**BBCO Wastewater Pretreatment
25 Omega Dr.
Williston, VT 05403
D&K Project No. 530759
ADDENDUM NO. 1**

This Addendum forms part of the Contract Documents and modifies the original Bidding Documents dated January 30, 2026. **NOTE: Contractor to Acknowledge receipt of this Addendum in the space provided on Page 1 of the Bid Form. Failure to do so may subject the Bidder to disqualification.**

PROJECT NAME:
BBCO
Wastewater
Pretreatment

E0.1

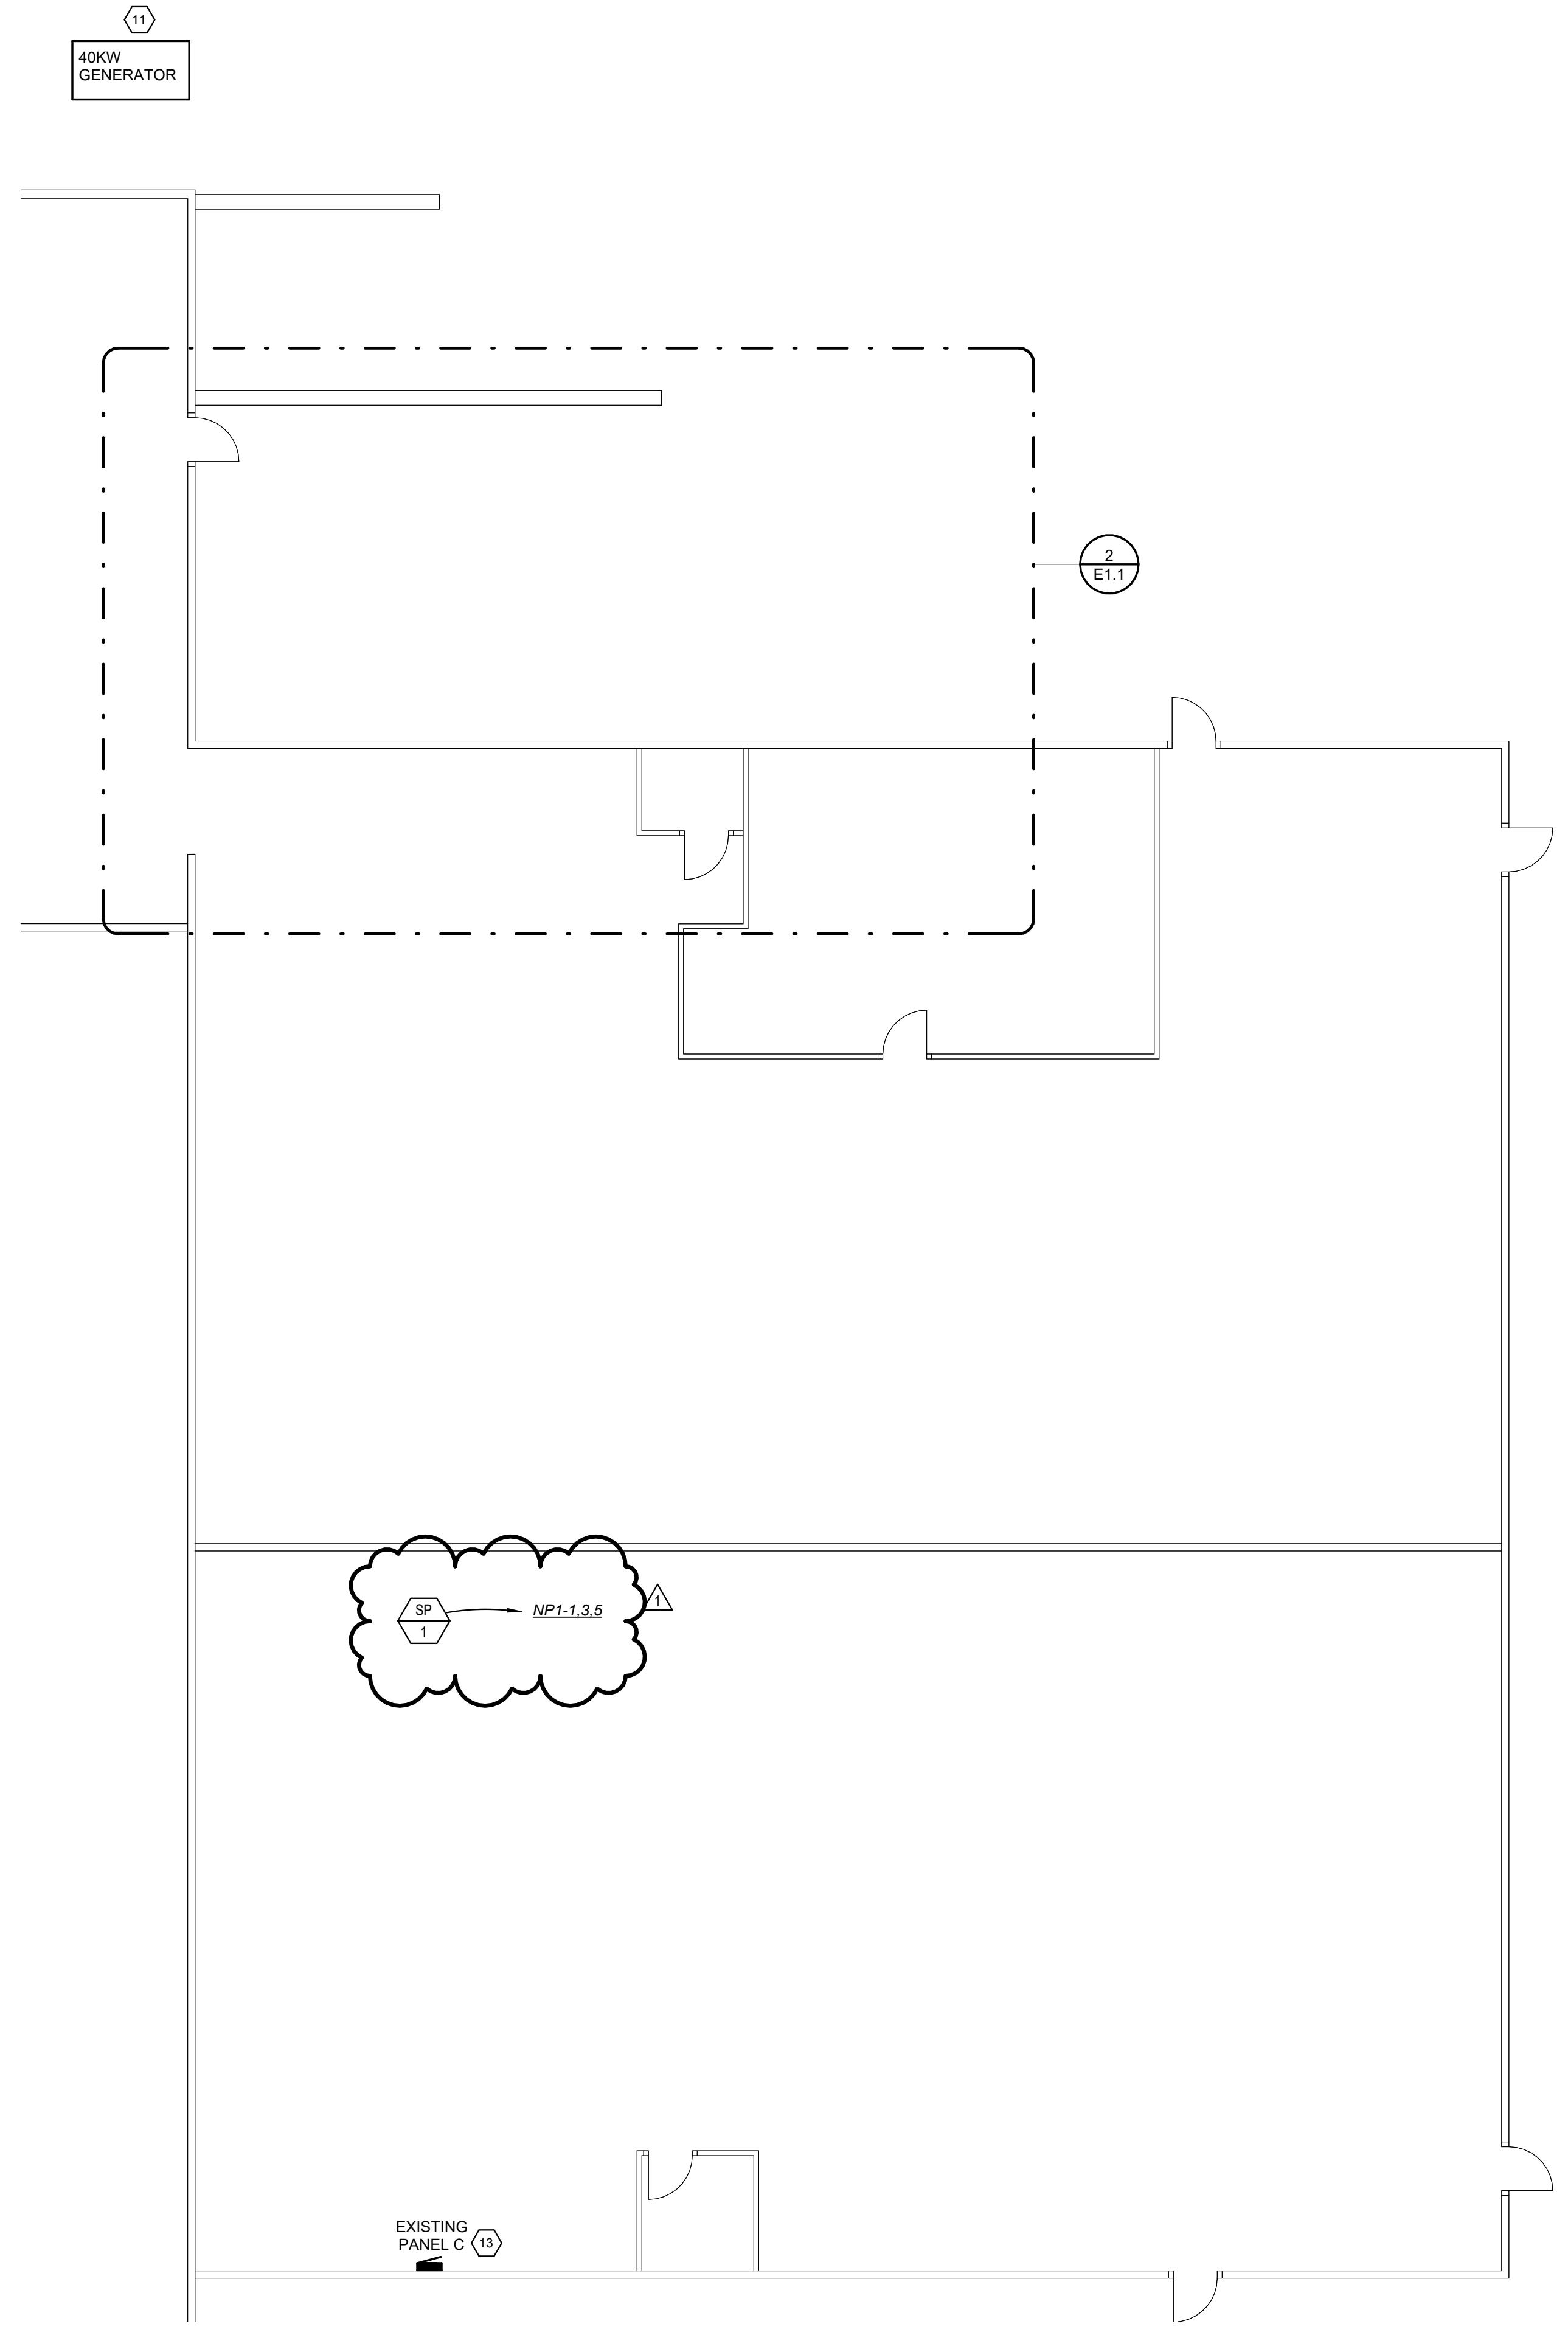
5. Drawing E1.1, keynote 15. Is this a one cable drop to each jack?

Response: Refer to attached revised E0.1.

E1.1

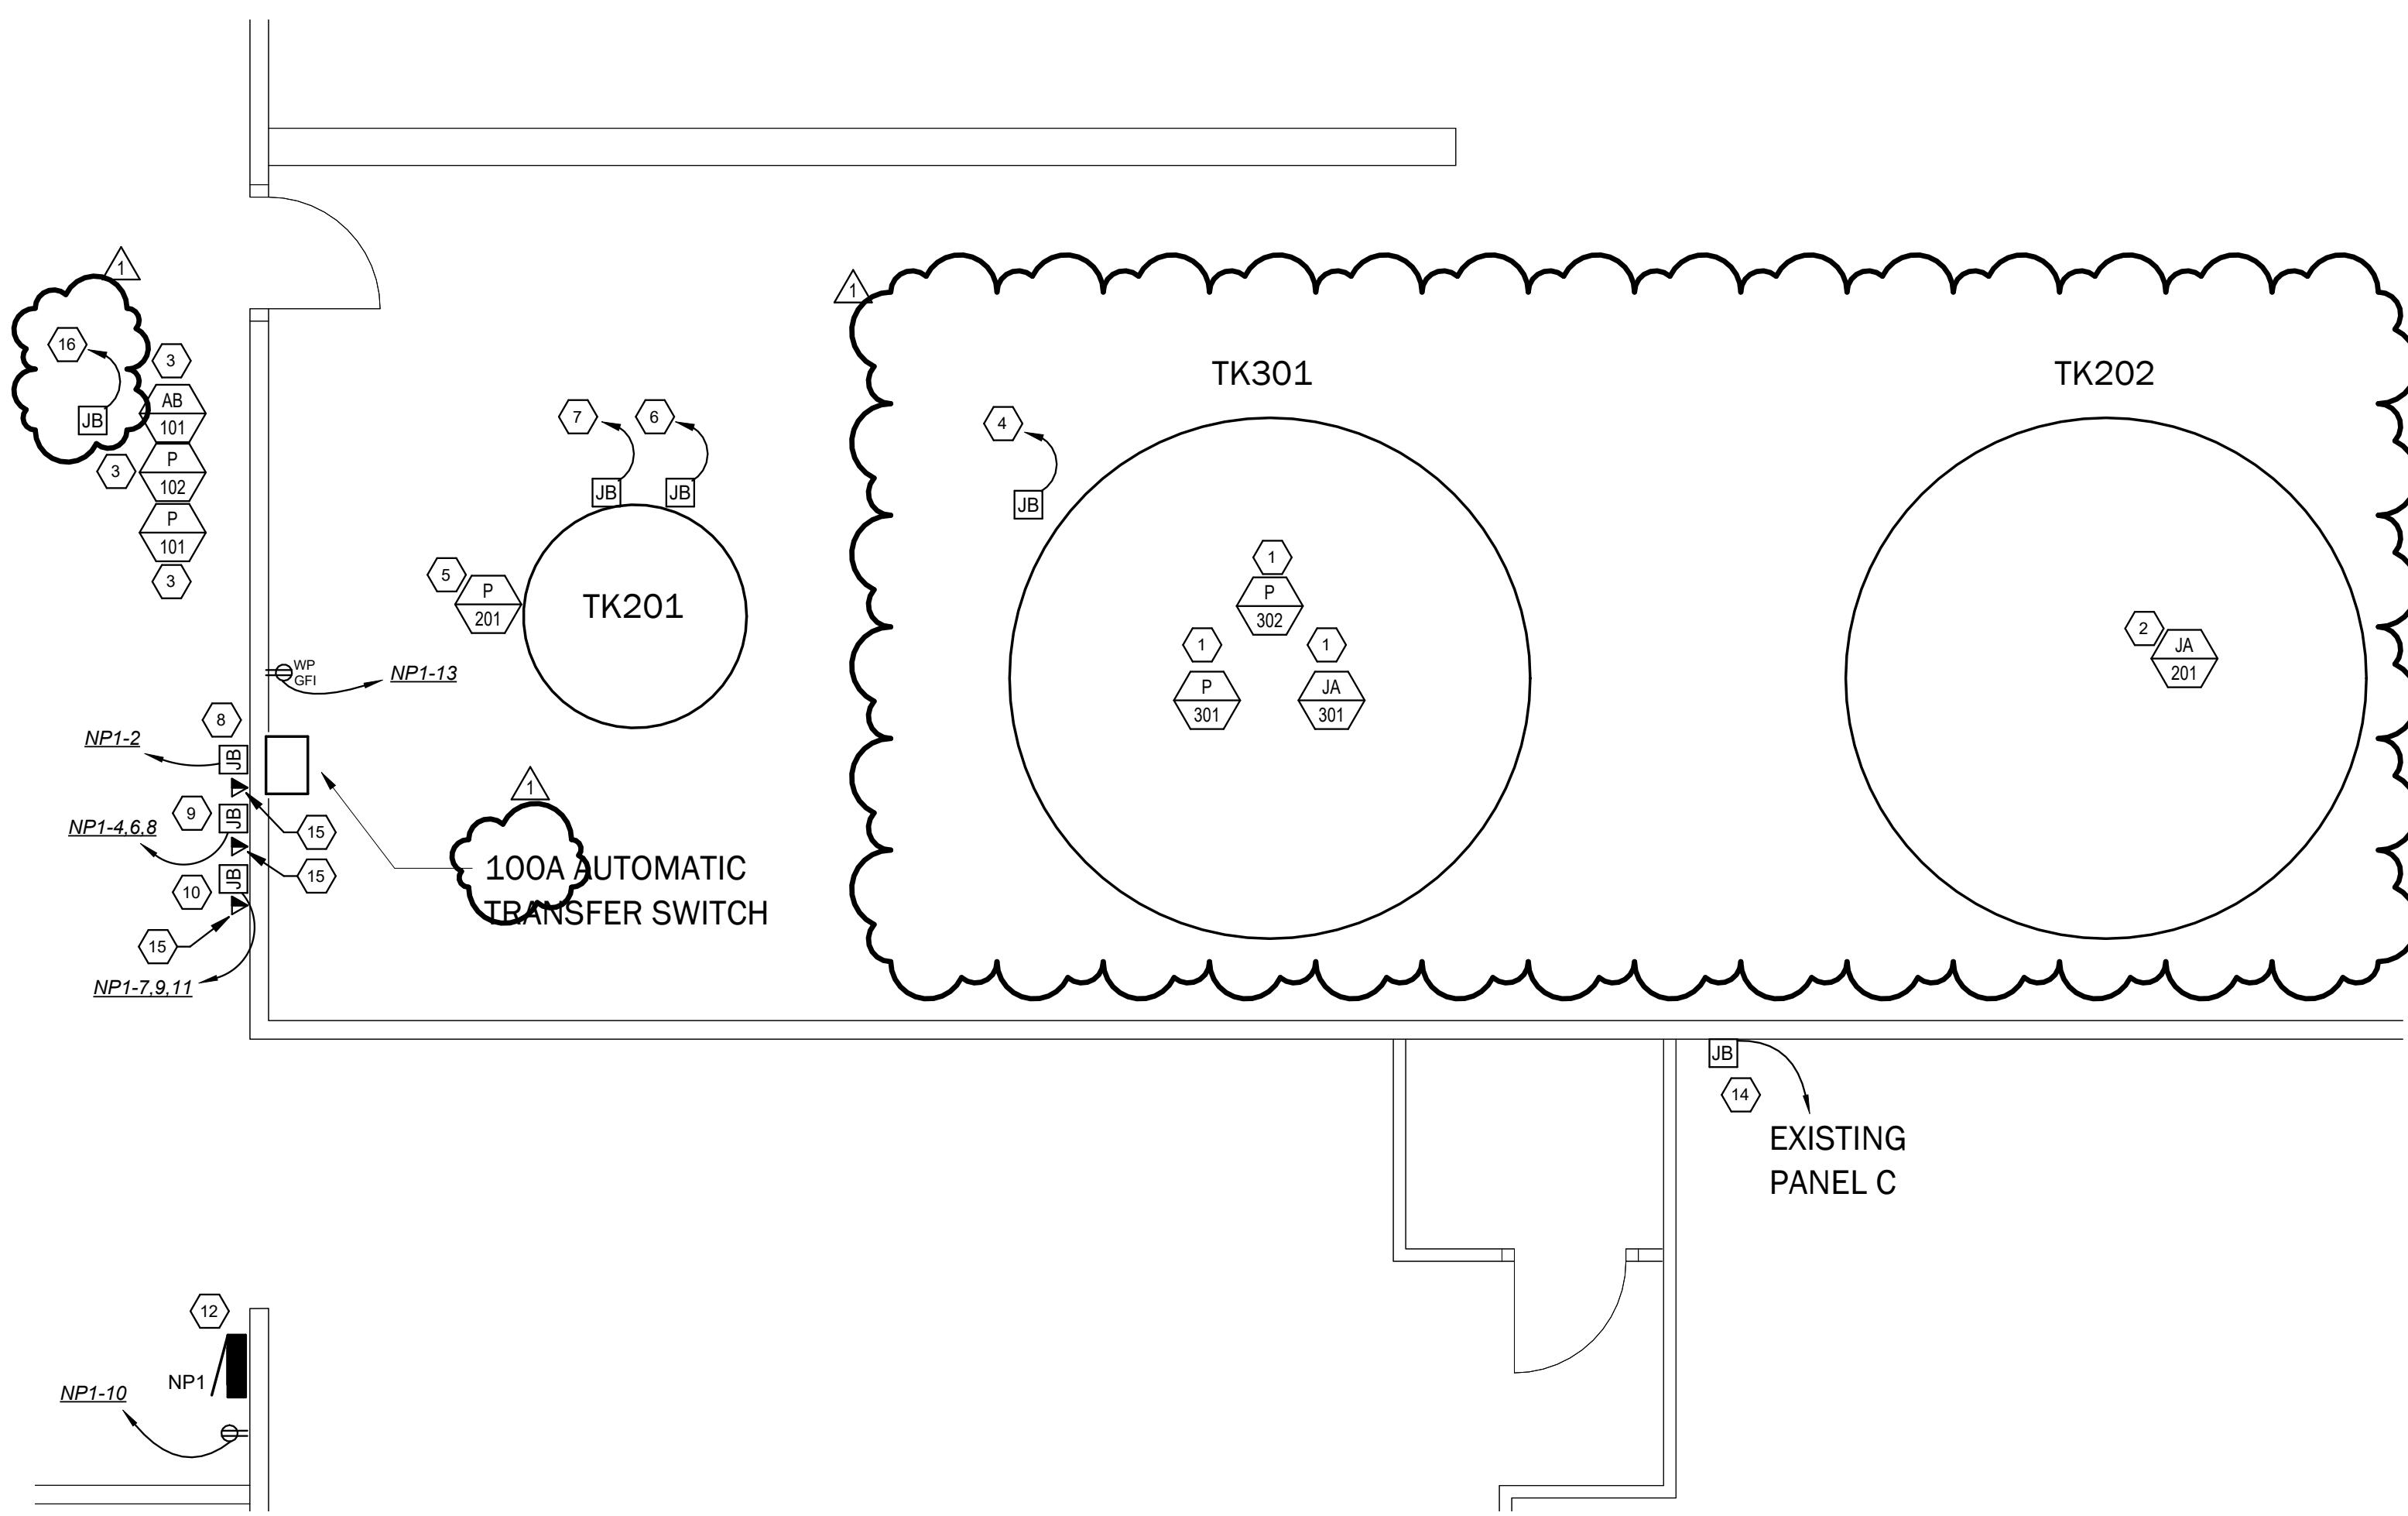
1. Regarding tanks TK301 and TK202. There is tank orientation conflicts between drawings C3 and E1.1. which is correct?

2. Sump pump schedule on drawing P0.1 indicates three phase, while schedule on drawing E1.1 and panel schedule on drawing E6.1 indicates single phase. Which is correct?

3. Drawing E1.1, Who is supplying the 150amp ATS? There's no notes or specs on this item.

Response: C3 is correct. Refer to attached revised sheet E1.1.

Response: SP-1 to be three phase. Refer to attached revised E1.1 and E6.1.
